# **802.3ck D2.1 Comment Resolution Cross-Clause Topics**

Matt Brown, Huawei, P802.3ck Editor-In-Chief  
Howard Heck, Intel

# Comment summary

## Tap Weights: Bch2\_b2p5\_7 with 31mm package

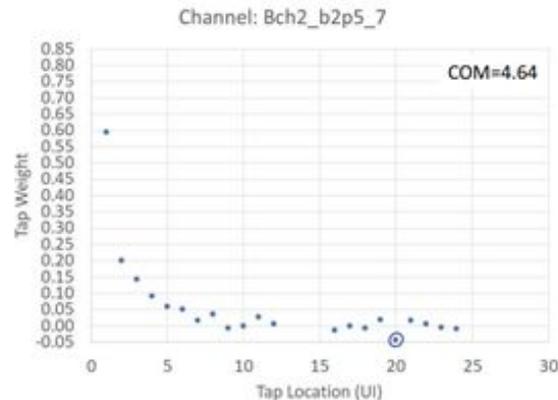
The following presentation showed that some backplane channels had floating tap coefficient values of <-0.03.

This channel has the WC minimum tap weight (-0.043 @ UI=20).
